ECK 6TH ADDITION

RE: S/D 99-56 -- Final Plat of ECK 6TH ADDITION

STAFF REPORT
(Final Plat Approved 10/21/99; Preliminary Plat Approved 8/19/99)

CASE NUMBER: S/D 99-56 - ECK 6TH ADDITION

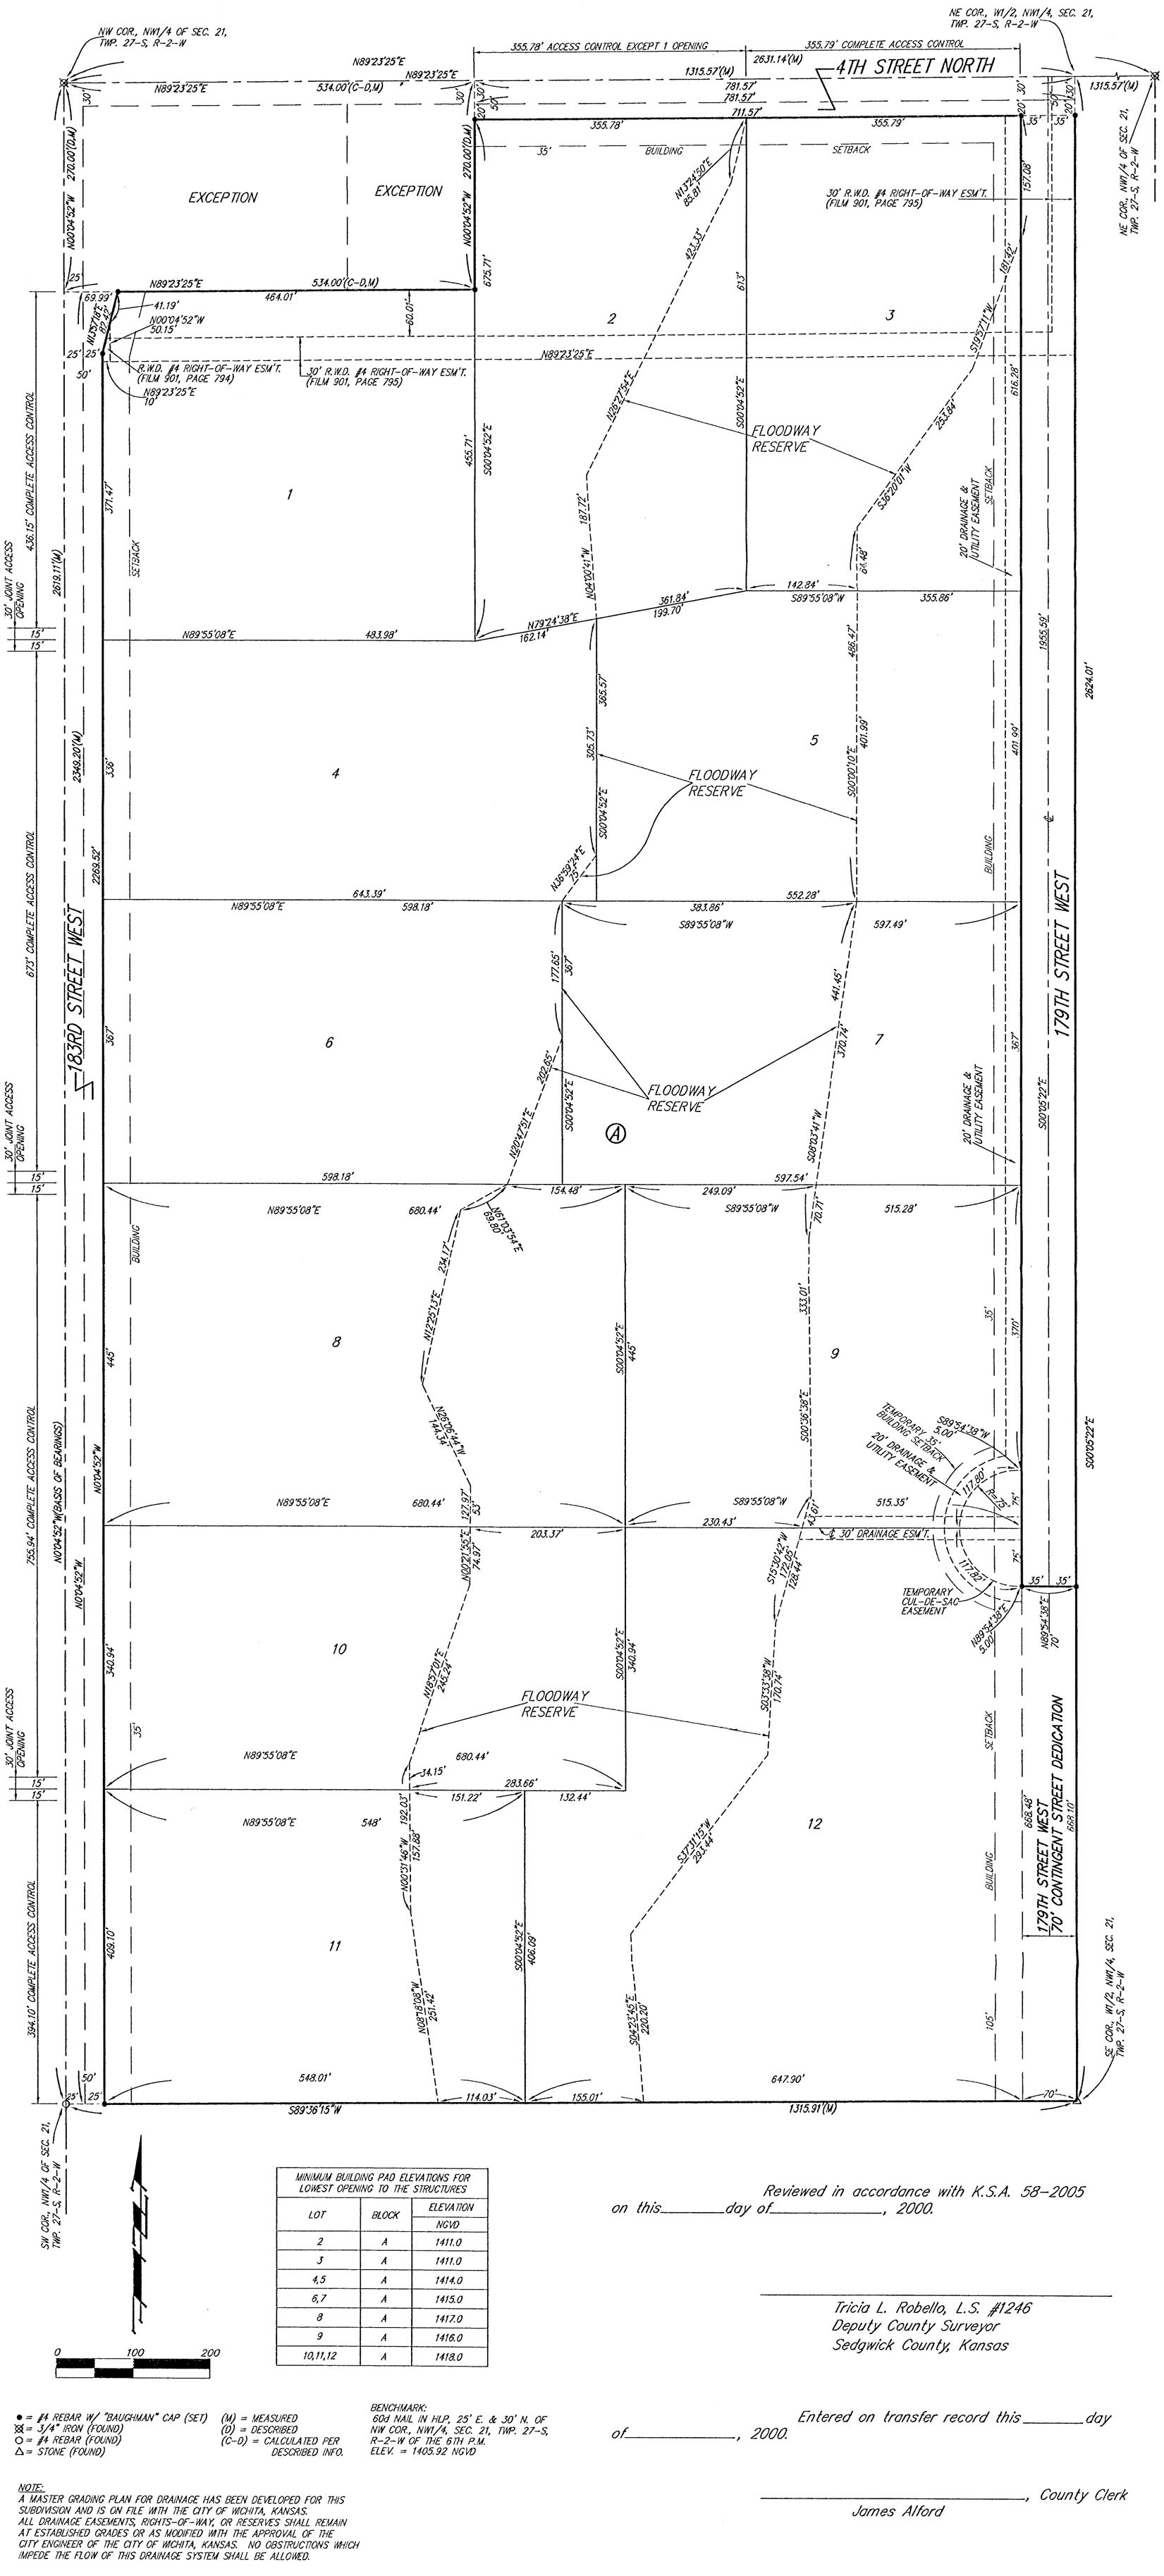
A. Since sanitary sewer is not available to serve this property, the applicant shall contact the Environmental Health Division of the Health Department to find out what tests may be necessary and what standards are to be met for approval of on-site sewerage facilities. A memorandum shall be obtained specifying approval. Health Department shall comment on the feasibility of on-lot systems for lots encumbered by the floodway reserve. *Health Department has required the submittal of a restrictive covenant denoting the layout of the sewage lagoons for Lots 3,5,7,and 9.*

B. *The site is currently served by Rural Water District No. 4. The applicant shall contact this water district to determine the ability of this property being platted to connect to their water line and submit a letter from the water district to that effect.*

C. County Engineering needs to comment on the status of the applicant's drainage plan. *A flood study is required*

D. County Engineering needs to comment on the access controls. The plat proposes three joint access openings along 183rd St. West and one access opening along Central. *The access controls are acceptable.*

E. County Fire Department needs to comment on the street name. *The street name has been changed to 179th St. West in accordance with County Fire's request.*

F. County Fire shall comment on the length of the interior street (1800 ft) which exceeds the 1200-ft limitation imposed by the Subdivision regulations. ***The development of property to the east shall provide a connection to 179th St. West.***

I. The plattor's text shall include language that a drainage plan has been developed for the plat and that all drainage easements, rights-of-way, or reserves shall remain at established grades or as modified with the approval of the applicable City or County Engineer, and unobstructed to allow for the conveyance of stormwater.

J. The applicant shall guarantee the installation of the proposed interior street to the suburban street standard. ***The street shall be constructed to the 36-ft rock standard.***

K. A County Commissioner signature block needs to be added as this site is located within the County.

L. The MAPC Chairman needs to be revised to reference "Frank Garofalo".

N. The applicant's engineer is advised that the Register of Deeds is requiring the name(s) of the notary public, who acknowledges the signatures on this plat, to be printed beneath the notary's signature.
